Virya Energy P.L.

12 April 2023

Submission in response to VNI West Consultation Report – Options Assessment (February 2023) on behalf of Virya Energy and the Meering West Wind Farm

Figure 1a: Existing power flow

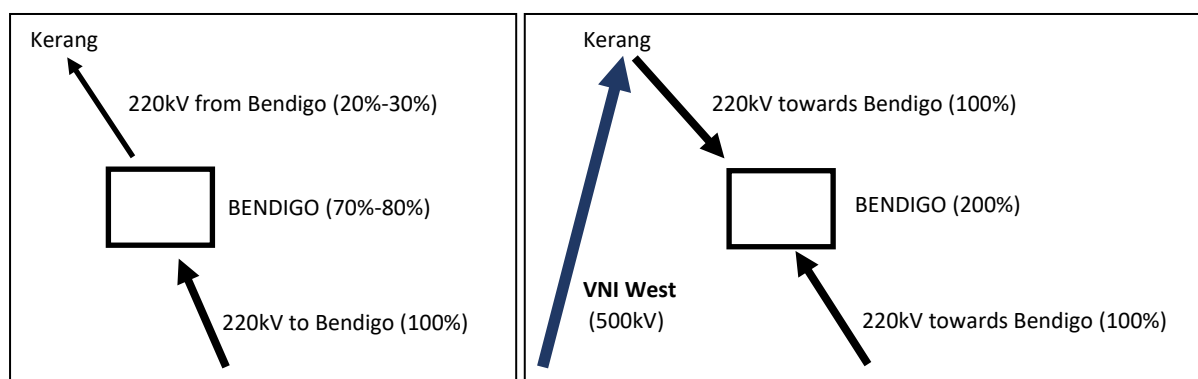
To summarise the diagrams above, most of the capacity of the existing 220kV line is used in the Bendigo region, say 70-80% (exact amounts to be confirmed by AEMO/Ausnet). Then the remainder, say 20-30%, continues north to Kerang, Swan Hill, Mildura, etc. When VNIW bypasses Bendigo and connects at Kerang, the power available in Bendigo more than doubles as there will be 100% of the 220kV line from Melbourne available, as well as 100% of the 220kV line from Kerang, hence a new spur line into Bendigo is superfluous and should be omitted from all options.

Figure 2: Bendigo spur line as shown in the Report.

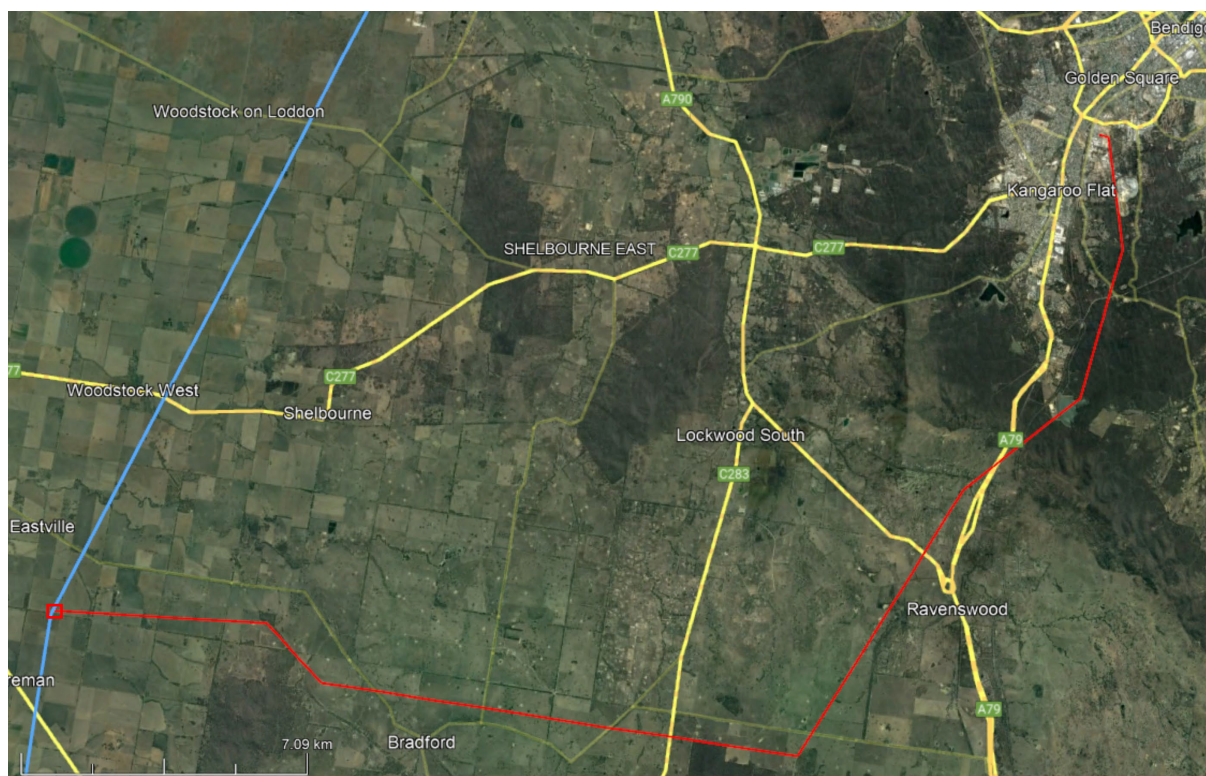
The removal of the substation and spur line into Bendigo, as shown in Figure 2 below, will save around \$500 million on Options 1 through to 4. Estimates based on the figures in the Report suggest that the omission of the spur line into Bendigo will save around \$350 million by not requiring a substation (red square) at the point where the Bendigo spur line (red line) would meet the line from North Ballarat (blue line). It would also save at least \$150 million worth of transmission line, however we note that this is based on the cost of \$4mil/km, calculated from average figures in the Report. The real costs are expected to be higher considering the value of lifestyle properties near Bendigo, the urban fringe and the Greater Bendigo National Park. Removing this section will also reduce the social impact penalties assigned to Option 1 through 4 because the Bendigo spur line passes through more densely populated areas, as well as the environmental and cultural heritage penalties for passing through both the Greater Bendigo National Park and the Bendigo Regional Park.

The removal of the 'near Bendigo' substation will save around \$350mil and the Bendigo spur-line removal saves around \$150mil, therefore \$500mil should be removed from the costs of Options 1, 3 and 3A. This improves Options 1, 3 and 3A as shown in Table 2 below:
